100/300 AREA UNIT MANAGER MEETING ATTENDANCE AND DISTRIBUTION

100/300 AREA UNIT MANAGERS MEETING
APPROVAL OF MEETING MINUTES

March 10, 2011

100/300 AREA UNIT MANAGER MEETING

From: Saueressig, Daniel G [mailto:dgsauere@wch-rcc.com]
Sent: Thursday, January 13, 2011 12:38 PM
To: Guzzetti, Christopher; Post, Thomas
Cc: Fancher, Jonathan D (Jon); Wilkinson, Stephen G; Landon, Roger J
Subject: 100-F-57 CHROME SAMPLING STRATEGY

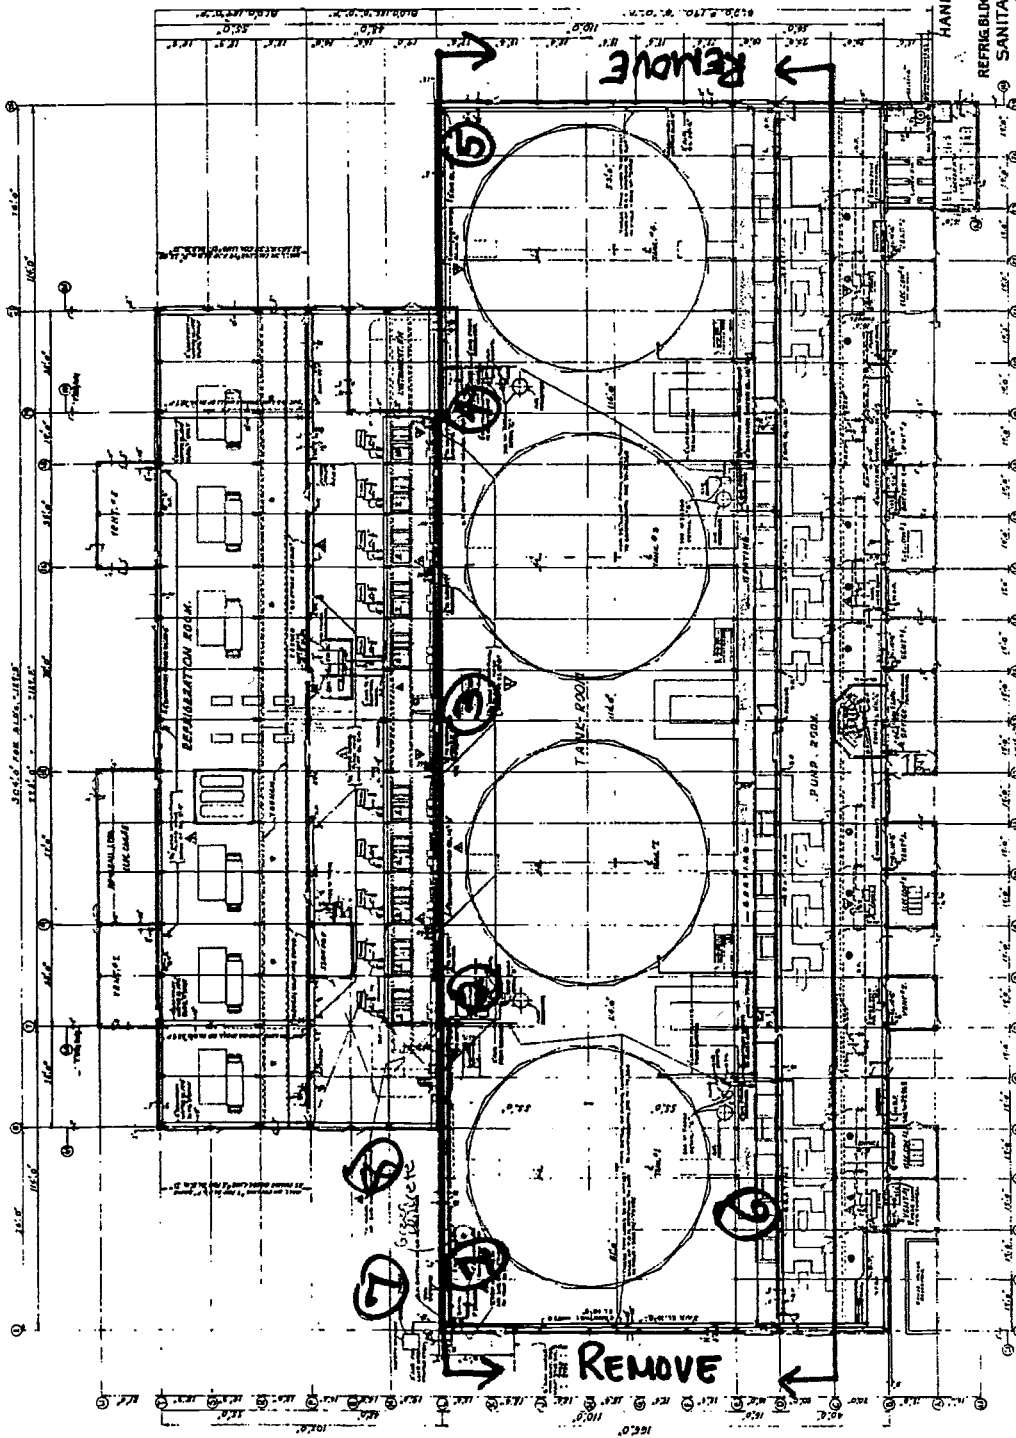
Chris/Tom, per our meeting yesterday, attached is a strategy (and drawing showing sample locations) we would like to propose related to determining the extent of the chrome contamination at 100-F-57. If you're in agreement with this strategy, we'll move forward and implement it and document this agreement at the next UMM.

1. Excavate test pits at 8 locations in/around 100-F-57.
2. Approximate excavation locations are noted on the figure.
3. Excavate to the maximum depth of excavator reach without benching.

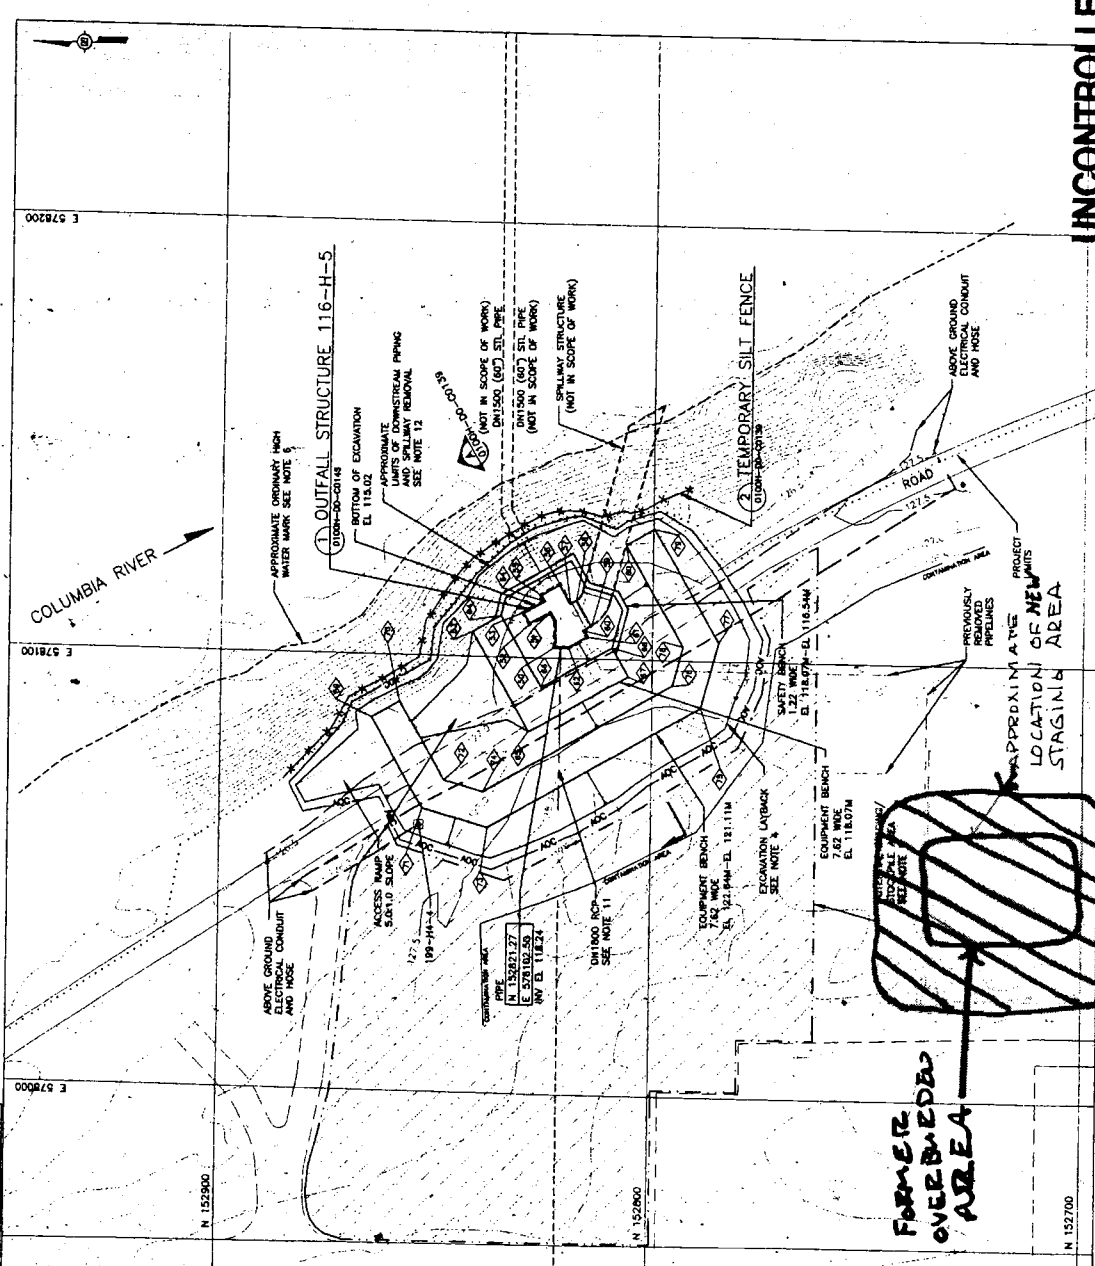
When documenting this agreement in the UMM please include the design drawing that details the location of the staging pile.

Hi Mandy, I'd like to request your approval to set up a waste staging area for staging material from the additional excavation planned at 116-H-5 (see attached drawing). The staging pile will be operated in accordance with Section 4.5.2 of the 100 Area RDR/RAWP (DOE/RL-96-17, Rev. 6). In addition, this area is not over any existing waste sites. This location was previously used for overburden from 116-H-5 during the initial remediation effort, and unfortunately, some of the overburden material was above the RAGs when verification sampling was performed. When load out of this material occurs, an additional foot of soil will be removed and disposed at ERDF, consistent with current practices. This

area will also be included in the closure verification work instructions for the 116-H-5.

Let me know if you concur with using this area for staging waste from 116-H-5, unfortunately, operations would like to start using this area next week.

Staging Pile Area: Ecology agrees with the path forward as described in Figure 2 and discussed on January 10th.
